Technical Bulletin

Passenger Side Airbag Cover

Number
9501

Model Affected: **911 Carrera Model Year 1995**

Figure 1

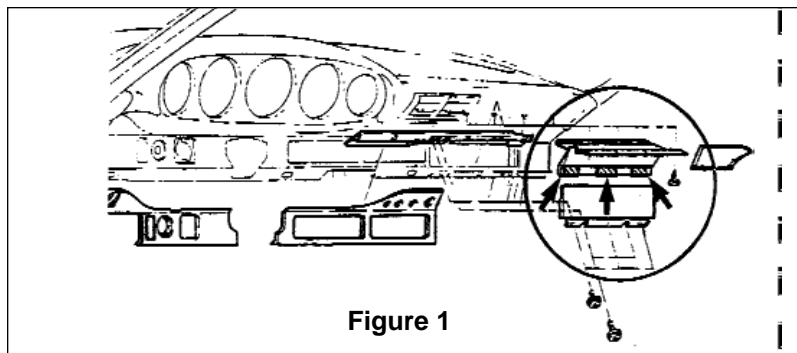
General Information: The two felt strips on the airbag covers on the passenger side of the vehicle have been replaced with three Teflon strips (figure 1) as of July 1, 1994 production from VIN's: 99XSS321420 Coupe
991SS341178 Cabriolet

Due to production reasons a few vehicles built after the above mentioned production date still received the felt strips.

Figure 2

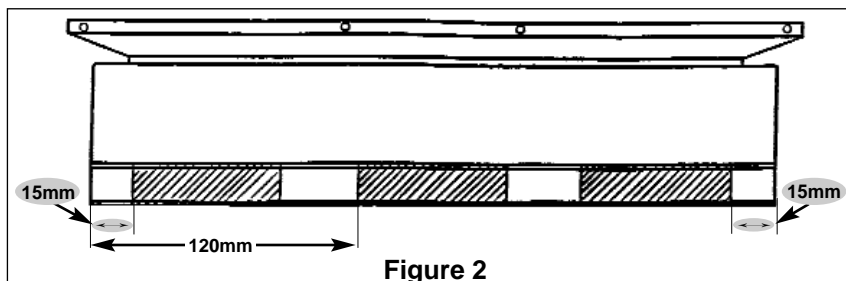
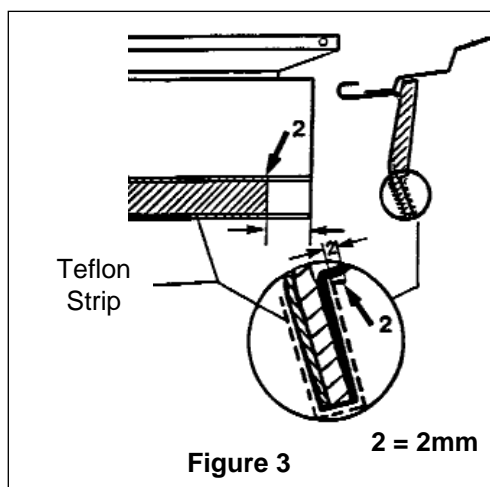
Repair Information: In case of noise complaints from this area, three (3) Teflon strips should be installed on the top cover (figure 2).

- Disconnect battery.
- Remove radio and radio frame.
- Remove Heater/AC vent, Heater/AC control head and frame.
- Remove ashtray.
- Remove kneebare and disconnect wires to the passenger airbag.
- Remove the lower airbag cover (3 bolts).
- Remove the felt strips on the upper airbag cover and install (3) Teflon strips at the dimensions shown in (figure 2). Start with the installation of the Teflon strips on the edge (circled area figure 2).

The Teflon strips must be installed approximately 2mm over the top radius of the upper cover (figure 3).
